Product Change Notification: E-20-012817

EEC Box family, EEC-325X4A, EEC-325X4A-E016, EEC-325X4B, EEC-325X4B-E016 Part change and new tooling release.

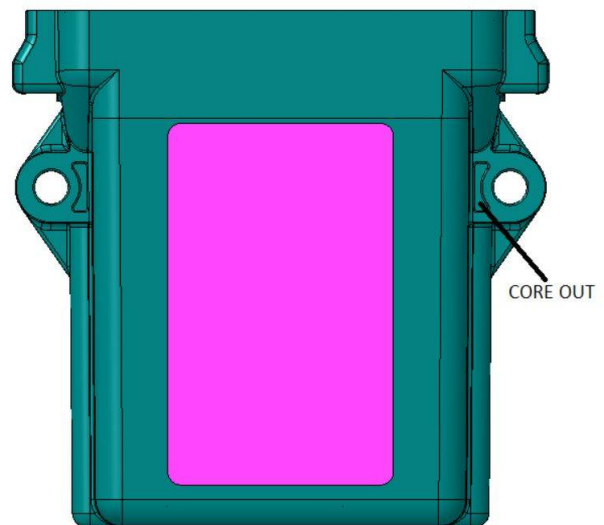
The Industrial and Commercial Transportation business unit of TE Connectivity is making a change to 1) Label from Deutsch shown on the inside surface to TE shown on the outside surface 2) Core out feature added and adjust the wedge to match the adjustment to the mold. 3) Addition of flow ribs to bottom inside surface to the numbers listed below. These PNs are TE proprietary designs, therefore considered catalog/general market product. PPAP and/or sample requests must be submitted within 14 days of PCN submission via ict-ppap-request@te.com or ePPAP system. Submission will not occur without request. If PPAP requested, disposition response is required within 14 days of submit date or it will be considered approved. Product drawings are affected.

NO CORE OUT

WITH CORE OUT
